FINDLAY CITY PLANNING COMMISSION

STAFF REPORT March 10, 2016

Thursday, March 10, 2016 - 9:00 AM

**RIGHT OR WAY DEDICATION
TOWNSHIP ROAD 145
PART OF THE SE 1/4 AND PART OF THE NE 1/4 OF SECTION 36, T-1-N, R-10-E,
CITY OF FINDLAY, HANCOCK COUNTY, OHIO
FOR
SENIOR HOMES OF FINDLAY, LLC.**

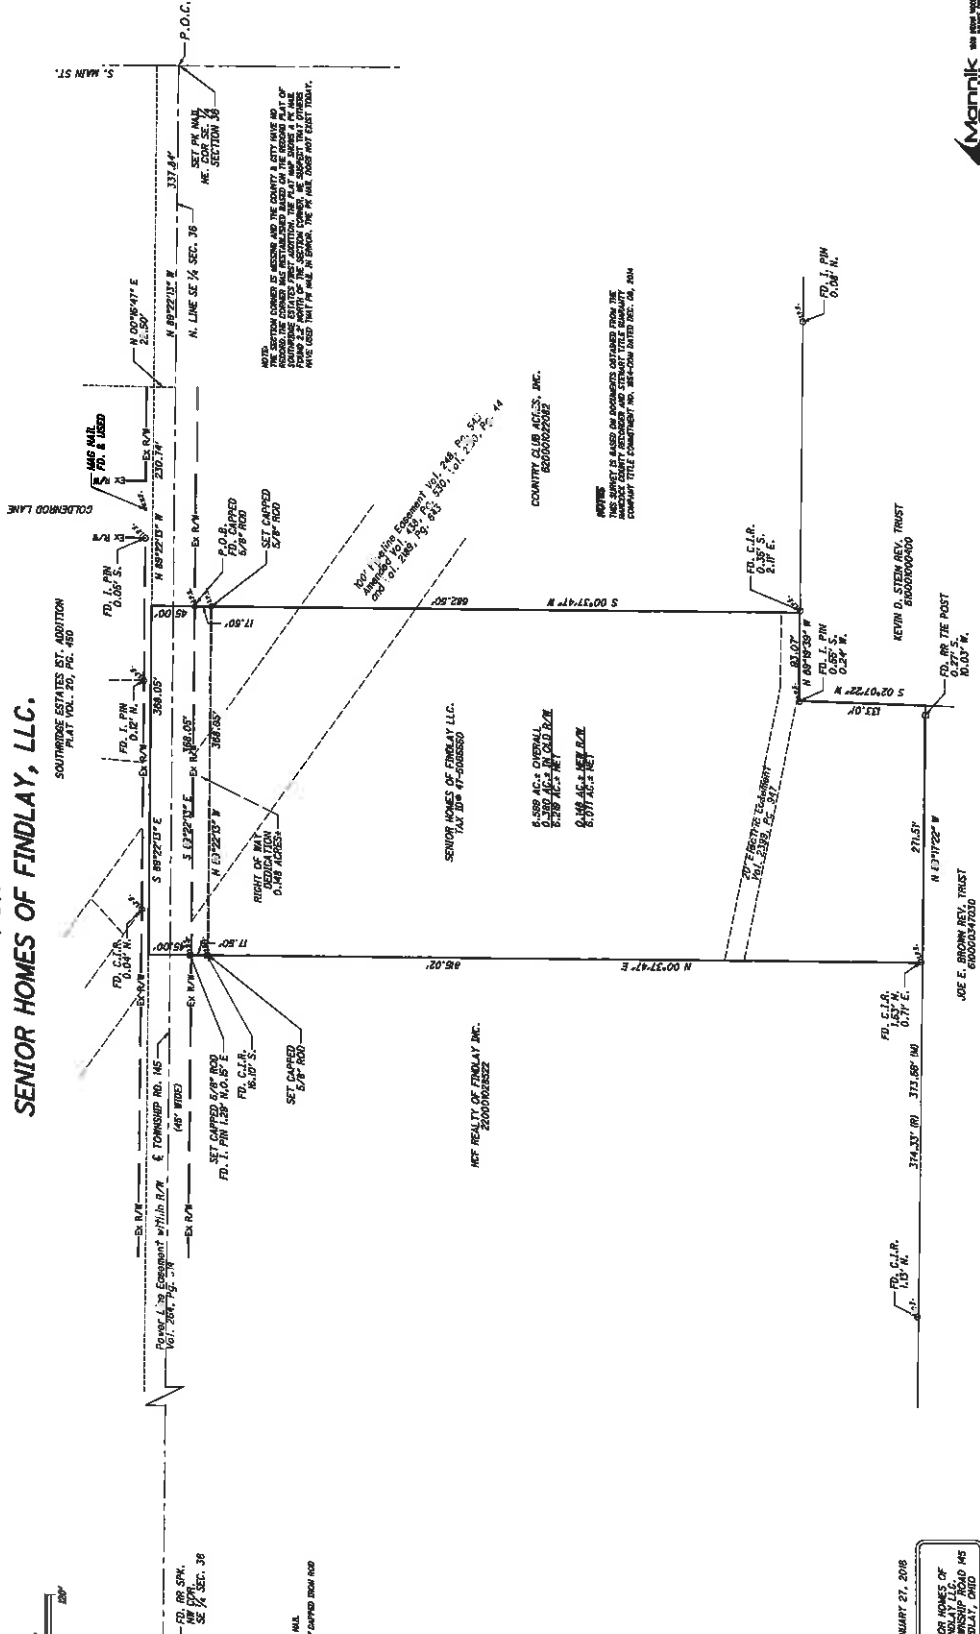
A condition of the approval of the site plan for this site was the dedication of additional right-of-way across the lot. TR 145 is labelled as a Secondary Thoroughfare on the City's Thoroughfare Plan. The current right-of-way is 45' in this area. The applicant was required to dedicate an additional 17.5' of right-of-way in order to reach the 40' from the centerline as required.

The existing right of way for Township Road 145 is in an easement. This means that the property owner owns the land but because of the easement, the City has the right to construct, maintain, rebuild, etc. the roadway as required. When we asked for the dedication plat as a requirement on the site plan for the senior housing project, the intent was to have both the existing right of way and the additional right of way dedicated to the City of Findlay. This would mean that the City would own the right of way and the property line for the senior housing project would become the south right of way line. If this is done, the senior housing project would still meet the lot coverage requirements in the zoning code and the property owner would not be paying taxes on property that is being used as public right of way.

The legal description that was submitted as part of the dedication plat is only for the additional right of way. The legal description needs to be revised to also include the existing right of way so that the end result is not the existing right of way owned by the property owner while the additional right of way is owned by the City.

Recommendations: Conditional approval of the dedication plat subject to the legal description being revised to include the existing right of way.

- the legal description being revised to include the existing right of way.

PRELIMINARY PLAN
Glenmar Subdivision
84.738 ACRES

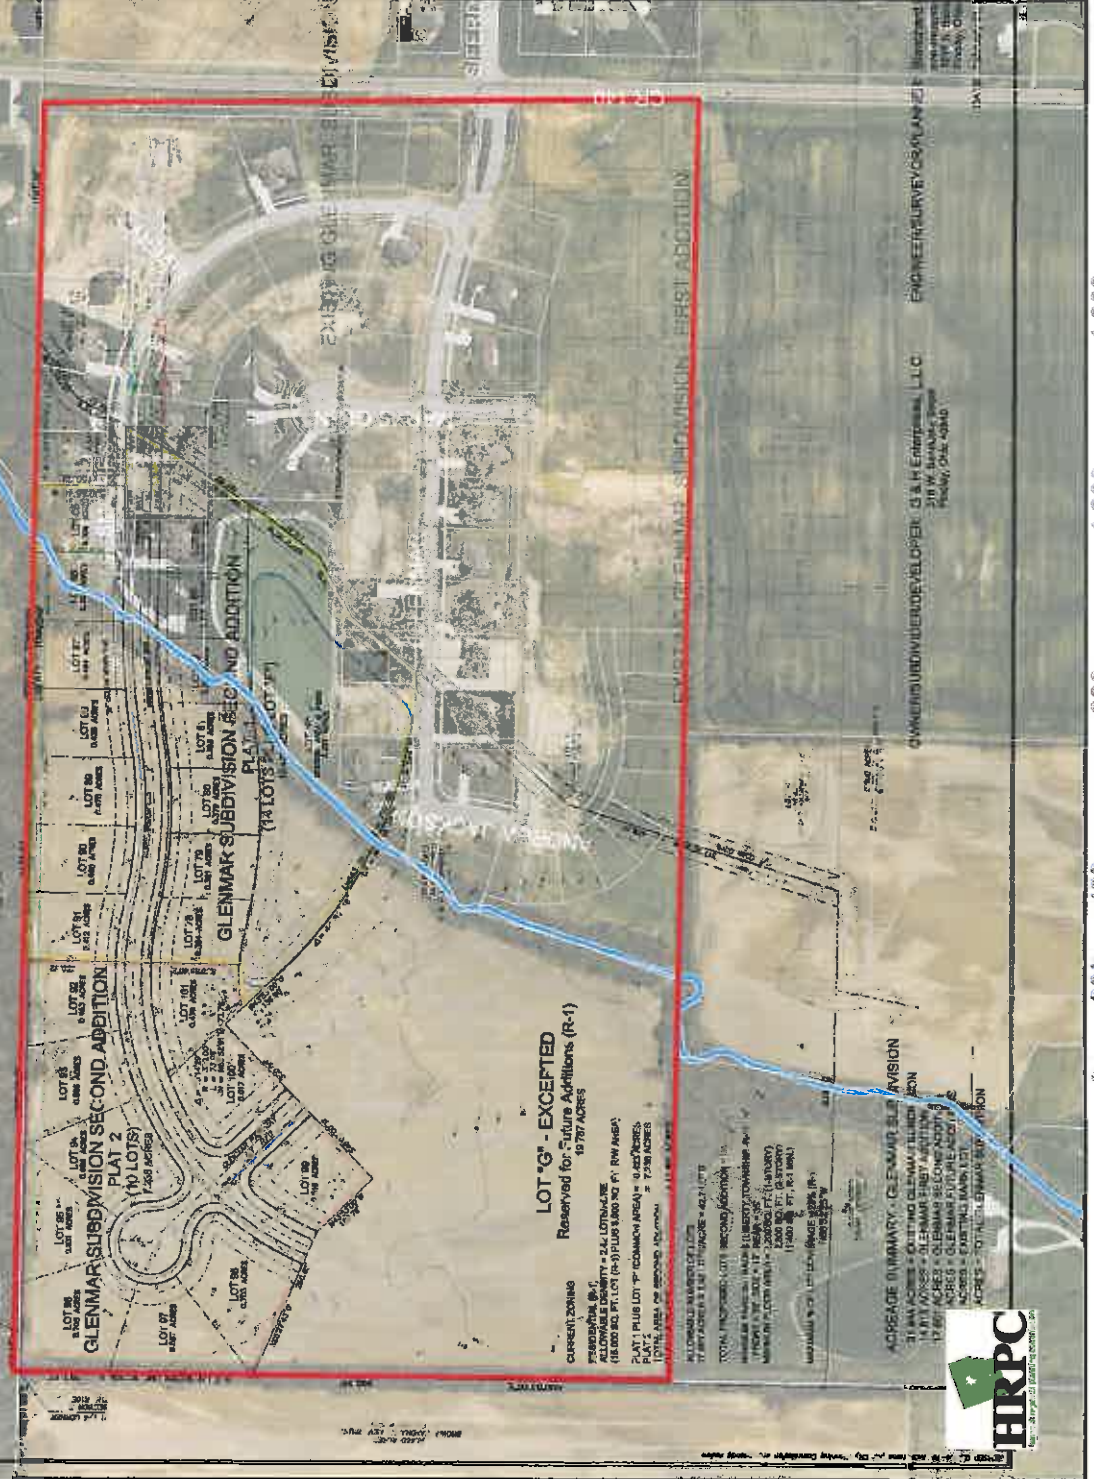
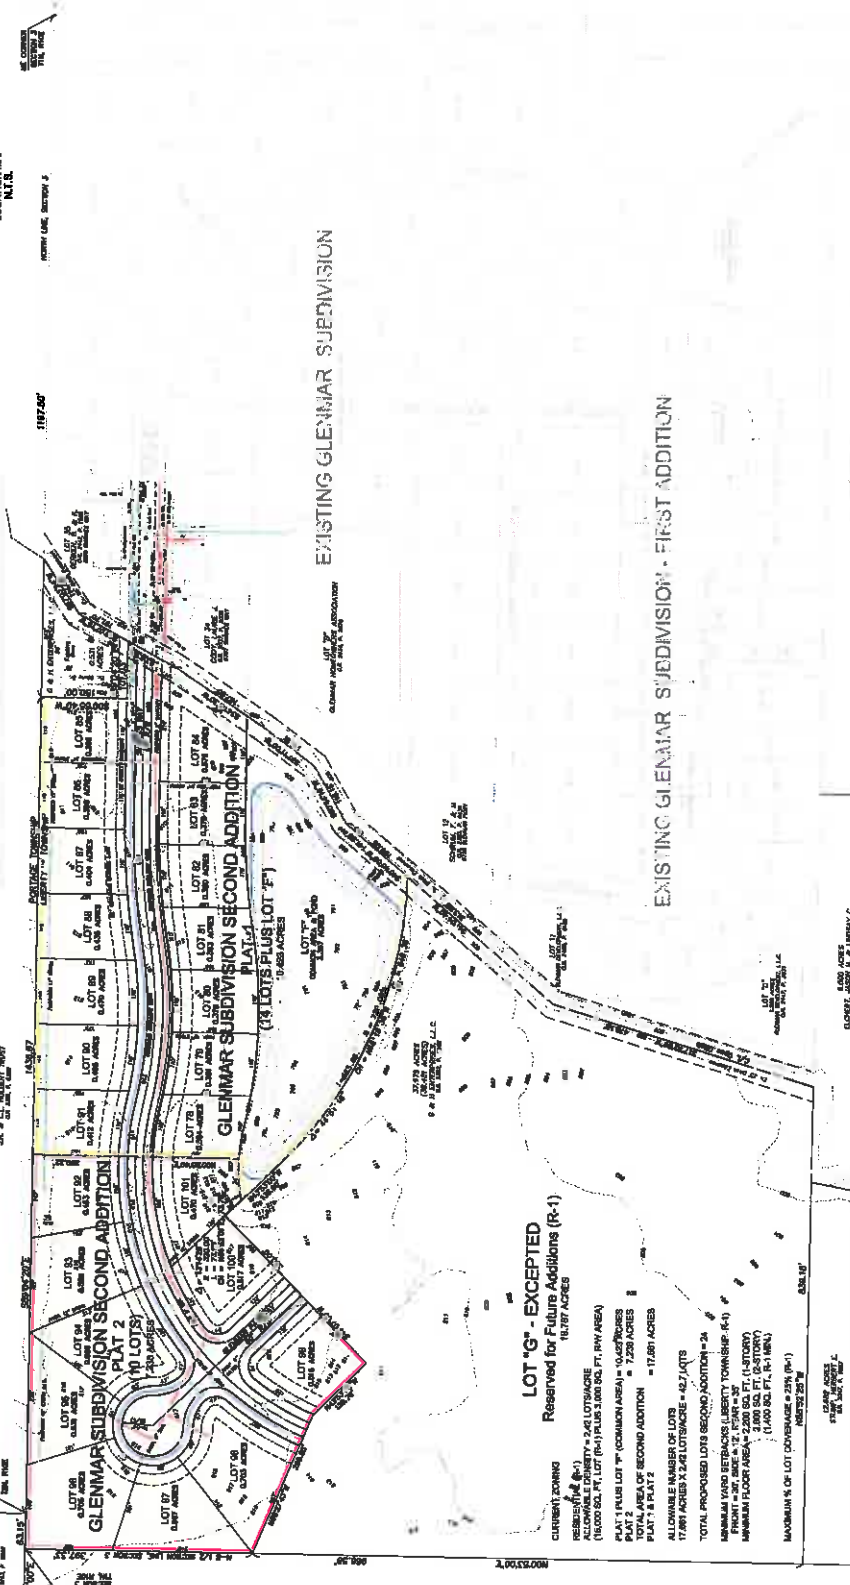
The applicant is presenting a new Preliminary Plat for the north portion of the land on the west side of the ditch. The plat shows 24 residential lots and a common area lot with a pond and is shown as developing in 2 phases. Smokies Way will be extended west across the ditch and a short cul-de-sac and stub of Glenmar Parkway will intersect in the northwest corner.

Lot sizes comply with the Liberty Township Zoning Resolution for size and width. The roads are public. There was discussion at the HRPC meeting in regard to type of curb that would be used. The Township wants only the straight curb, but the Subdivision Regulations require curb and gutter for public streets. The original sections of the subdivision have curb and gutter except for the Villa phase on Andrew Jackson Lane. The bridge across the ditch on Smokies Way will provide the transition area to switch to the straight curb. The County Engineer is responsible for reviewing and approving the construction drawings, and he was going to meet with the Township on this issue before Final Platting of the subdivision.

Subdivision Regulations also require that stub streets be shown when there is undeveloped acreage abutting a proposed subdivision to allow for connectivity of a street system in the future. There is not a stub street shown to the north. HRPC discussed this issue as well. The land directly north (approximately 57 acres) is in Portage Township. The Township has zoning, but the entire township is currently zoned Agriculture. The Agricultural zoning only allows one building permit per 35 acres. As it stands today, it is not likely to ever become a residential subdivision. HRPC decided to give a variance on that requirement. A stub street will be required to the west when the rest of the subdivision (currently exempted from the plat) is platted. There is a stub street to the south from Andrew Jackson Lane east of the ditch

The Deputy County Engineer had read the Covenants and Restrictions that the developer had submitted and advised them to apply for a County Petition Ditch according to ORC in order for the County to accept maintenance for drainage and the detention pond.

- **Approval of variance on the requirement to have a stub street to the north**

- **Changes be made to the Covenants and Restrictions as recommended by Deputy Engineer, Doug Cade**

SITE PLAN
 1 inch = 40 feet

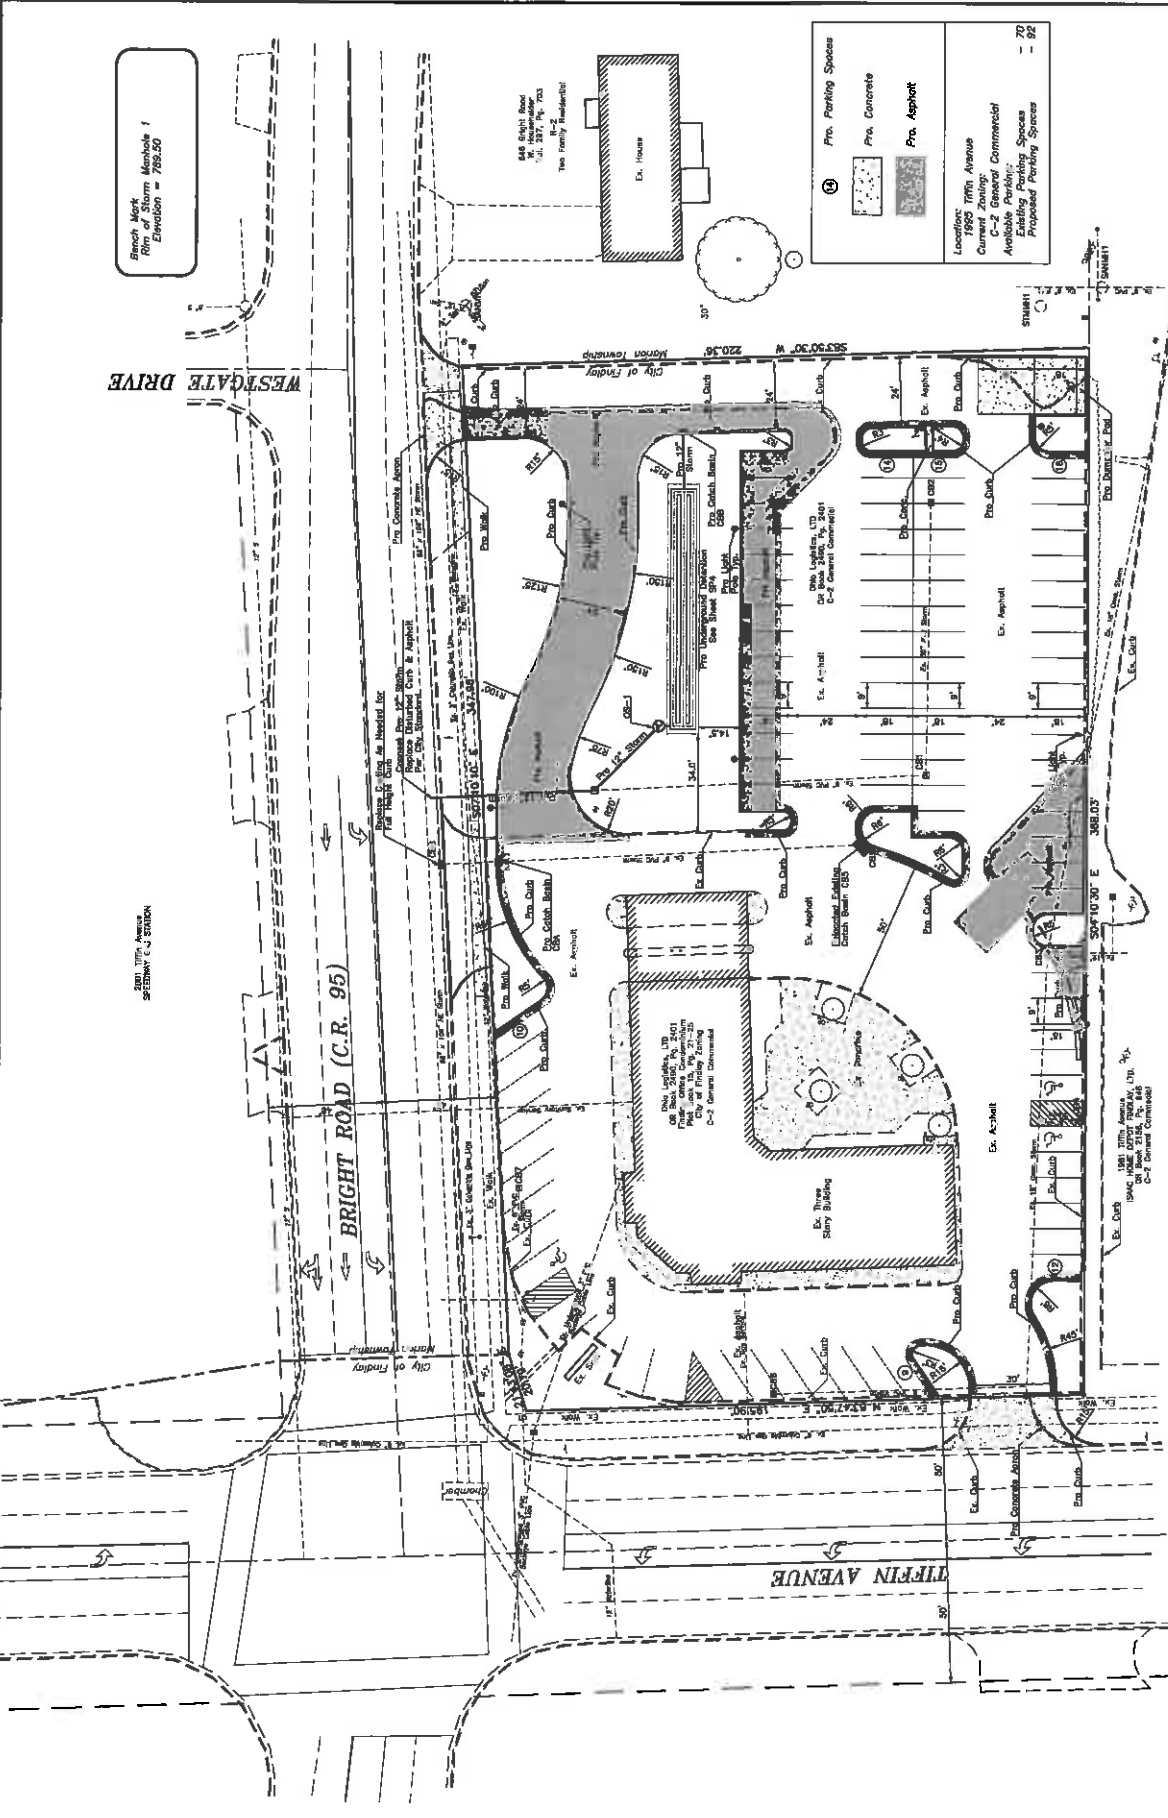
The applicant is proposing to reconfigure drive lanes and some of the parking layout surrounding the building.

The drive opening on the southwest corner of the lot (Tiffin Avenue side) is being widened. The parking along the south property line is being changed from angled to 90-degree parking. The result will be an increase in spaces from the existing 24 to 30 spaces. The spaces abutting Tiffin Avenue will have a net loss of 2 spaces with the widening of the ingress/egress.

The lot directly behind (east side) the building is also being changed from angle to 90 degree and some additional pavement added. The change will increase the parking spaces from 24 to 43 in this area. Bump outs and islands are added to the lot as well.

Access on the north (Bright Road) side is being taking down from three (3) spots to one (1). The access will be widened here as well and a new paved driving lane connecting the access to the building area is being added across the current grass area.

New landscaping is proposed for the remaining grass area and will also include some outdoor seating. The bump out and island areas of the parking lot are planted as well. The dumpster has been moved to the southeast corner of the lot and will be hidden with vinyl privacy fencing.

A photometric plan shows a maximum of .5 foot candles at the east property line. This meets the requirement of the code. The fixture details call out a 25' pole. From the drawing it appears that the pole is slightly higher than the head of the light fixture. If that is the case, it does meet the maximum height of 25' in the code.

Access – The site is currently accessed by three (3) drives and the old drive for the house that has been demolished is still existing. The applicant is proposing to eliminate the old house drive and

the drive on Bright Road that is closest to the intersection. The remaining two (2) drives will be widened to allow easier access to the site and are located as far from the intersection as they can be. Engineering would prefer to see the entire drive aprons be replaced instead of matching the proposed concrete up to the existing concrete.

Stormwater Management – Stormwater detention is being provided by a proposed underground detention system located in the grass island area. The design calculations submitted meet the City of Findlay Standards.

Sidewalks – There are existing sidewalks on Tiffin Avenue and Bright Road. New sidewalk will be added in areas where drives are being removed and any areas where the sidewalk is currently damaged or becomes damaged due to construction traffic.

- The entire drive aprons be replaced instead of matching the proposed concrete up to the existing concrete.

- The entire drive aprons be replaced instead of matching the proposed concrete up to the existing concrete. (ENG)
